**ADDENDUM NO. 1**

PROJECT: Pima County Adult Detention Center Jail Tower HVAC Upgrade

### PIMA COUNTY ADULT DETENTION CENTER JAIL TOWER HVAC UPGRADE

Re: Pima County Adult Detention Center - HVAC Upgrades  
Addendum to Construction Documents  
KC project No. 14-263.1

M1.0

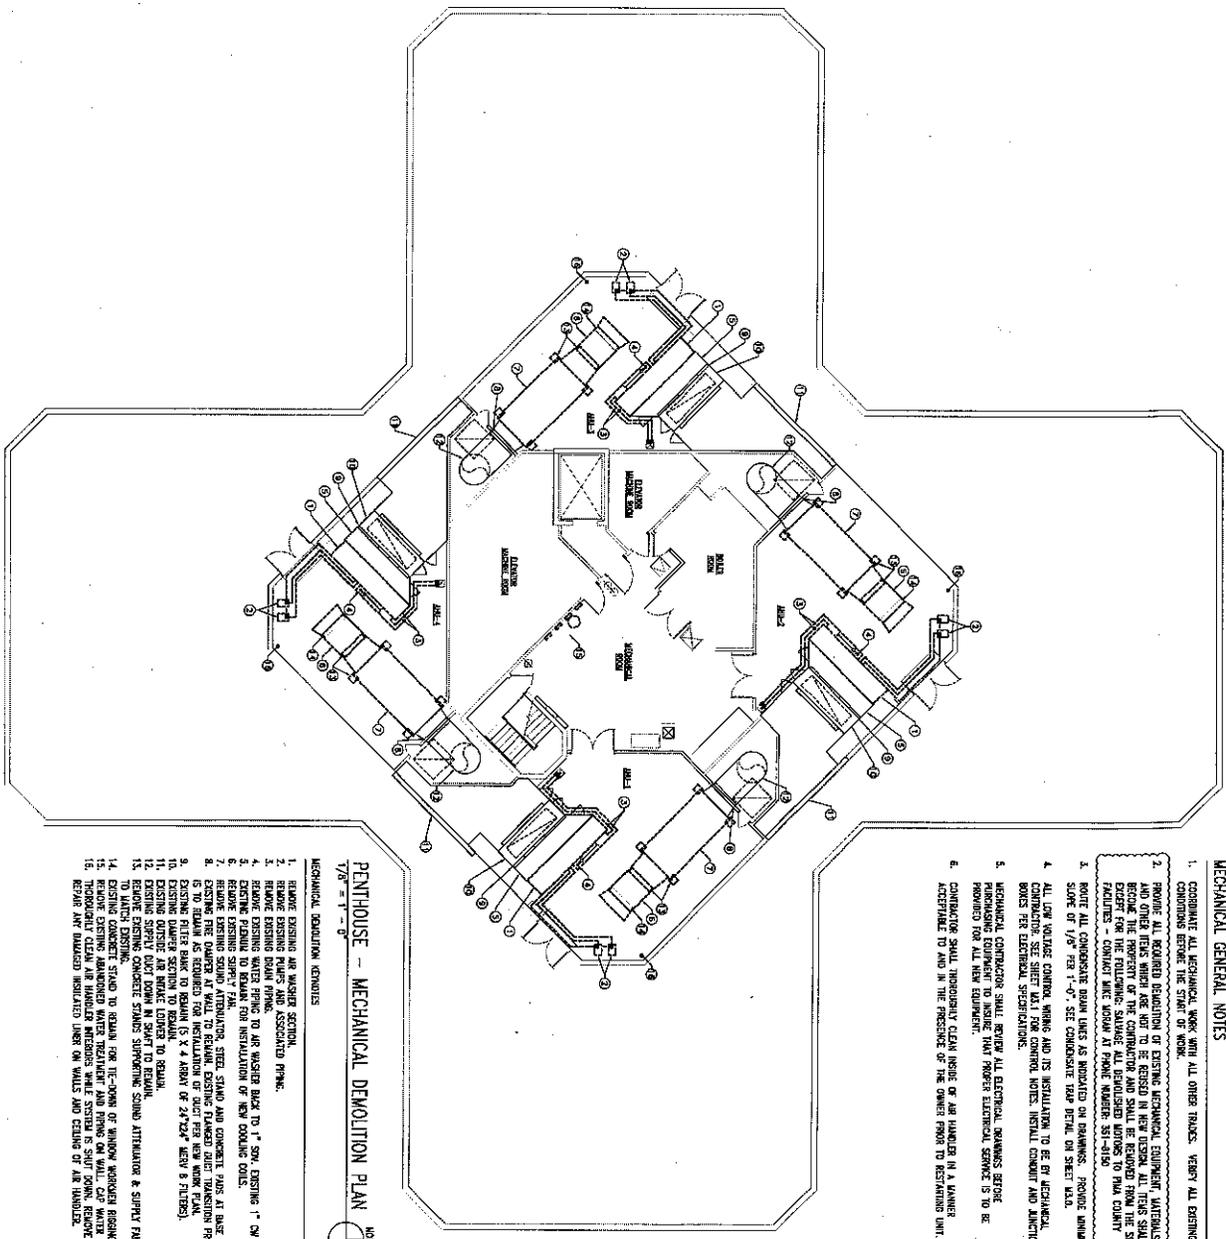
- Sheet M1.0 - changed the second sentence in General Note 2 to read:  
"ALL ITEMS SHALL BECOME THE PROPERTY OF THE CONTRACTOR AND SHALL BE REMOVED FROM THE SITE, EXCEPT FOR THE FOLLOWING:"
- Sheet M2.0 - at keynote 8, changed the detail reference from "DETAIL 3" to "DETAIL 8."
- Sheet M5.0 - under the Mechanical General Requirements, added the requirement for 3 sets of the O&M Manuals.
- Sheet M1.0 - the last sentence in General Note 4 ends with "PER ELECTRICAL SPECIFICATIONS.", but there are no electrical specifications.  
Electrical specifications are issued under this addendum.
